NEDO-33284 Supplement 1-A
Revision 1
eDRFSection 0000-0112-6090 R1
March 2012

MARATHON-ULTRA CONTROL ROD ASSEMBLY

SUBJECT: FINAL SAFETY EVALUATION FOR GE HITACHI NUCLEAR ENERGY
AMERICAS TOPICAL REPORT NEDE-33284P, SUPPLEMENT 1,
"MARATHON-ULTRA CONTROL ROD ASSEMBLY" (TAC NO. ME3524)

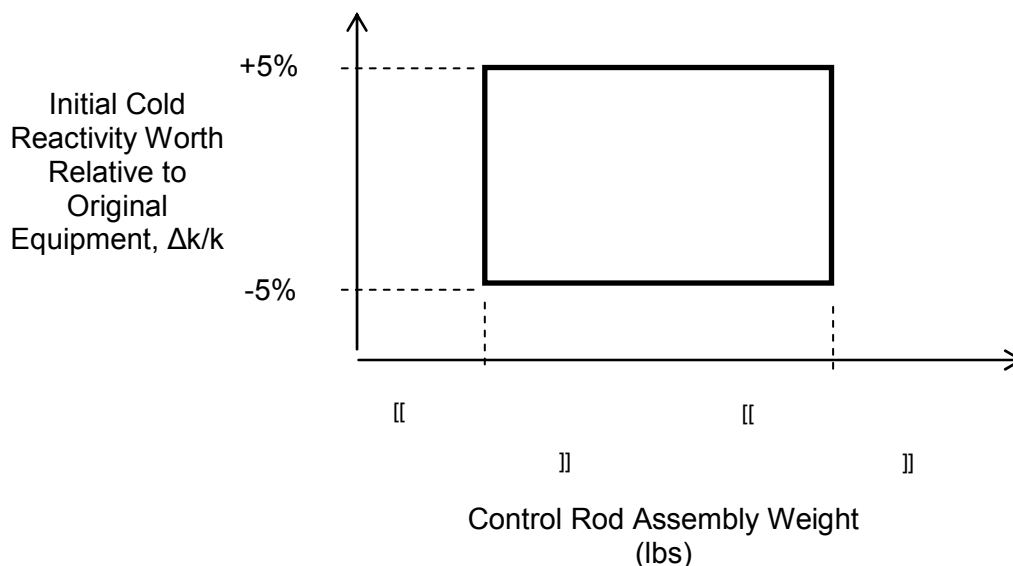
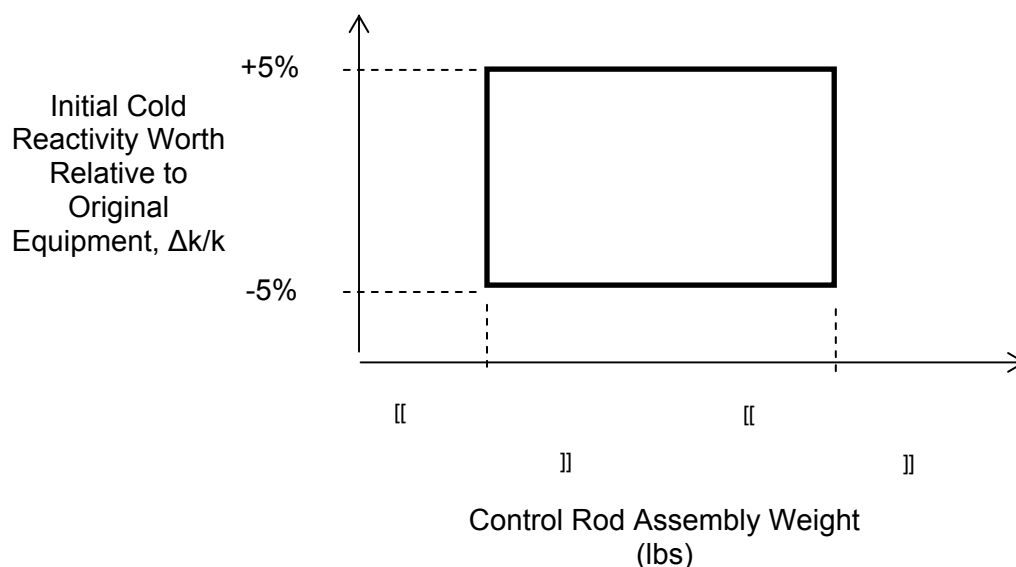
The NRC staff had concerns with some wording in Section 10 of Reference 1, specifically the text “methodology equivalent to that in Section 4.2.” The GEH response to RAI-7 clearly states that methodologies used to evaluate any future alternative absorber loading will be identical to the methodologies reviewed by the NRC staff and that the nuclear analysis methodology shall not be modified unless specifically reviewed and approved by the NRC staff.

In the final, approved version of this TR, Section 10 should be modified to clearly state that the

design change process is not applicable to ABWR and ESBWR. Conforming changes may also be necessary throughout the TR.

With regards to Section 10 of NEDE-33284P Supplement 1.

- GEH confirms that alternate load patterns employed under Section 10 of NEDE-33284P Supplement 1 will not include partial length hafnium rods, but will instead only include full-length hafnium rods.

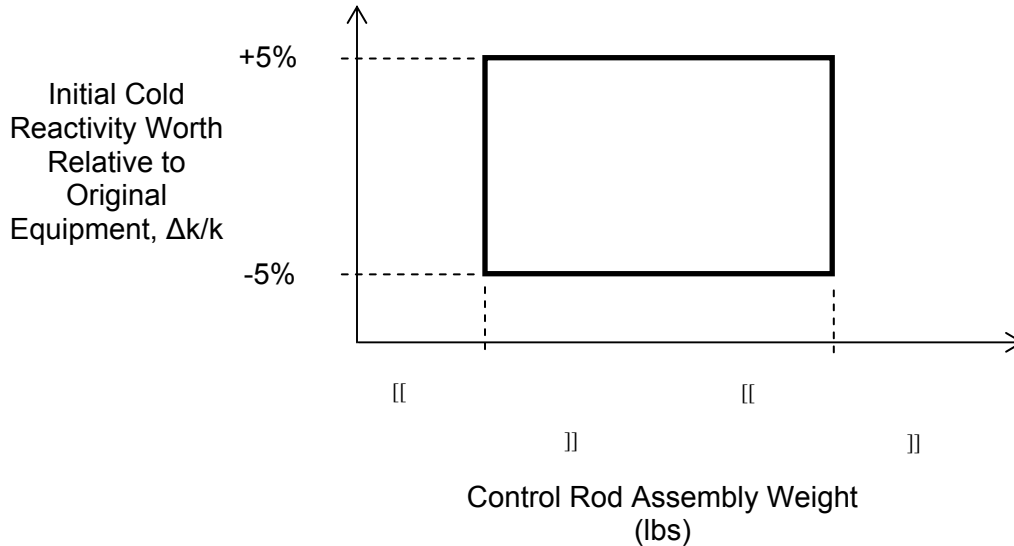
- The NRC staff is considering imposing a letter notification requirement, similar to the GESTAR-II process, on any Marathon-Ultra control blade design with an alternative absorber loading pattern. The notification would provide detailed specifications of the alternate absorber loading pattern for each lattice configuration, document the acceptance criteria used to judge its performance, and confirm compliance with these criteria. Discuss the use of a notification process for future design alterations.
